Client: **QUEENSTOWN LAKES DISTRICT COUNCIL**  
Project: **ROBINS ROAD WASTEWATER UPGRADES**

# ROBINS ROAD WASTEWATER PIPELINE UPGRADE FRAMEWORK CONSTRUCTION NOISE AND VIBRATION MANAGEMENT PLAN

As requested, Acoustic Engineering Services have reviewed the WSP Construction Noise and Vibration Impact Assessment (CNVIA) and Management Plan (CNVMP) which accompanied the RM241070 Application. We have also reviewed the subsequent addendum dated the 17<sup>th</sup> of February 2025, which describes minor design changes and provides detail on a preferred micro-tunnelling construction methodology.

Figure 2.2: NSR locations in relation to the Project

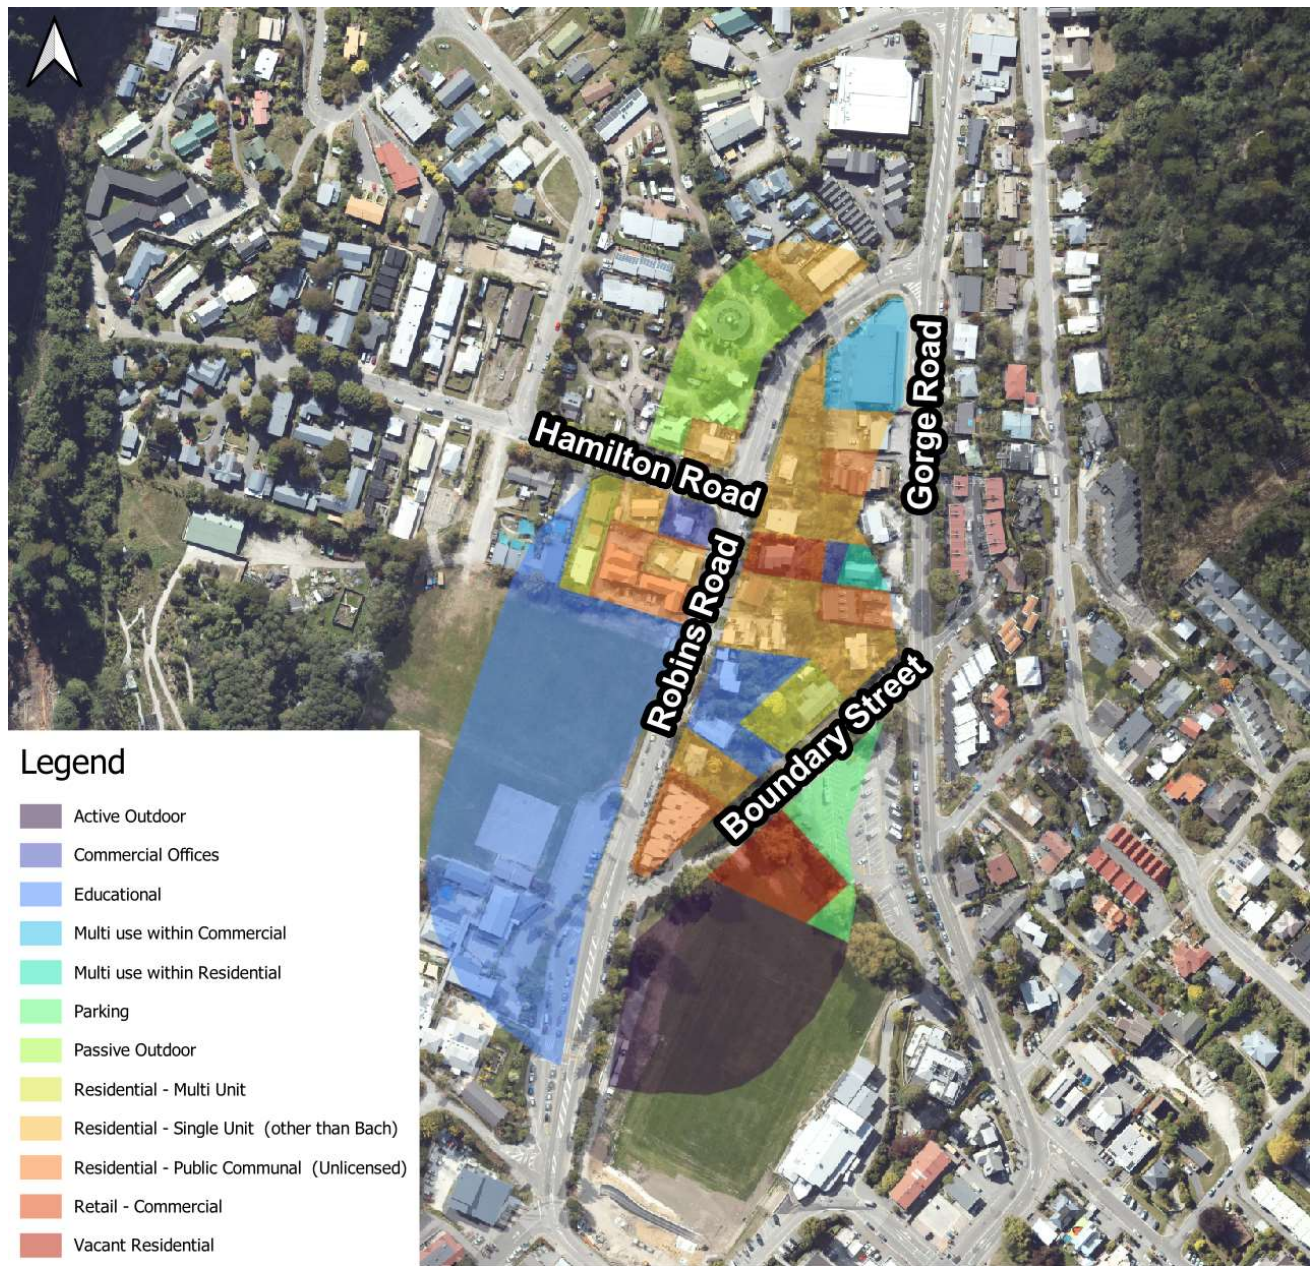
The closest noise sensitive receivers are highlighted in Figure 2 of the CNVIA. A figure showing the possible extent of non-complying sheet piling levels is also shown in Appendix A of the addendum. This covers more properties than Figure 2 of the CNVIA – because sheet piling occurs further east to accommodate one of the micro-tunnelling pits. More detail on the properties expected within the setback for key activities is also provided in Appendix A of the addendum. We agree that the properties most likely to be affected by noise and vibration from the proposed works have been correctly identified by WSP.

Noise and vibration effects will reduce with distance from the worksite. For receivers at the outer extent of Figure 2 on the last page of the addendum (for example those south of Gorge Road and 17a Fryer Street), it is likely that noise levels will generally comply with the construction noise limits for the majority of the works, due to distance and likely screening effects – although this is difficult to confirm without undertaking a more detailed review of relative heights. The properties south of Gorge Road will also be exposed to higher traffic noise levels, which may reduce apparent noise effects.
